Our Ref: 200483
Your Ref: DA20/2056

275 Bong Bong Road, Broughton Vale
Submission re: DA20/2056 for proposed Tourist and Visitor Accommodation

Figure 2: Extract from proposed Site Plan

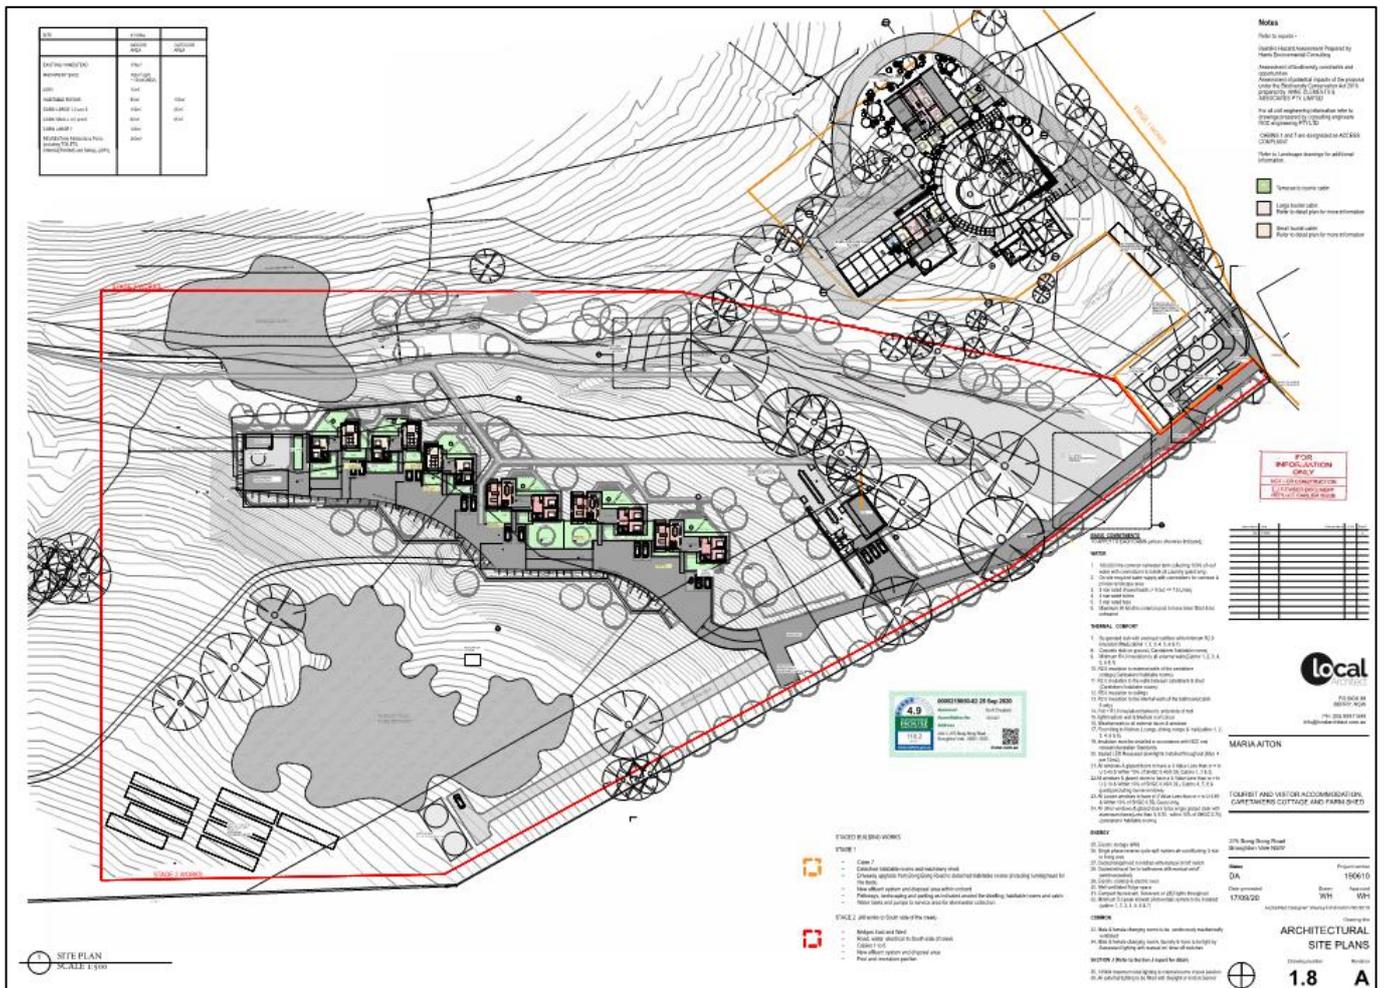
* It is noted that the Site Analysis Plan submitted with the DA does not adequately identify surrounding development in accordance with section 5 of G1 (SDCP 2014) thereby limiting the capacity of Council to review the surrounding locality.

The development proposed incorporates significant variations to the maximum 120m² floor area for Tourist Cabins as identified on the proposed Site Plan. This is mainly due to the definition also including "all decks and verandah areas". Refer to Table 1 below for details of non-compliance.

Figure 4: Extract from Proposed Site Plan identifying Detached Habitable Rooms

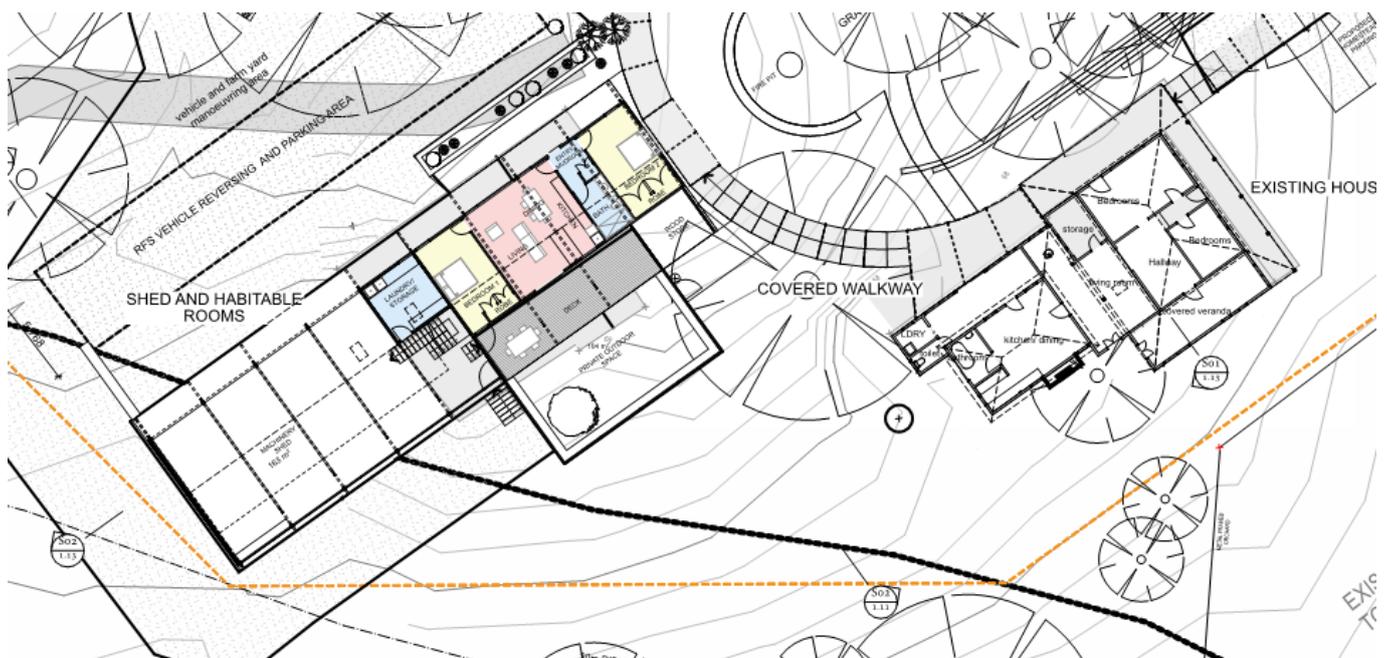
The proposed development incorporates a two bedroom dwelling that has been categorised as 'detached habitable rooms' for the purpose of complying with SDCP 2014 Clause 6.3.2. There are a number of inconsistencies identified in the design following review of SDCP 2014 and the proposed detached rooms are considered to further represent the overdevelopment of the site.

The proposed 'habitable rooms' incorporate gross floor area of 105m² in addition to 15m² for a dedicated laundry space accessed from the machinery sheds and 105m² of private open space. The design, scope and scale of the building is inconsistent with the intent of SDCP P27 that requires the primary dwelling and the detached habitable rooms to operate as a single dwelling house. The two dwellings will not function as a single house and will clearly promote opportunity for separate rental or occupancy of both buildings as separate domiciles.

The additional 'habitable rooms' provide bathroom and kitchen facilities with a laundry located under the same roofline. For the purposes of characterising the proposed development, the habitable rooms are considered to be self-contained and the proposal is inconsistent with P27 which requires the detached rooms to be reliant on the principal dwelling for laundry, bathroom or kitchen. Plans confirm the principal dwelling has its own bathroom, laundry and kitchen.

The proposed covered walkway access between the primary dwelling and the detached habitable rooms is designed entirely to meet the provisions of the DCP clause. The detached habitable rooms provide fenced outdoor open space that is independent of the primary dwelling and will function as a separate dwelling. The habitable rooms are therefore considered to represent a separate accommodation and it is requested that Council review and provide clarification on the permissibility of this additional development based on LEP and DCP controls.

Further to the above, the design of the proposed laundry will readily provide internal access through future construction of a door into the bedroom or shed walkway. Refer to Figure 4 extract of architectural Site Plan below identifying the independent design of the two buildings and non-compliant laundry location.
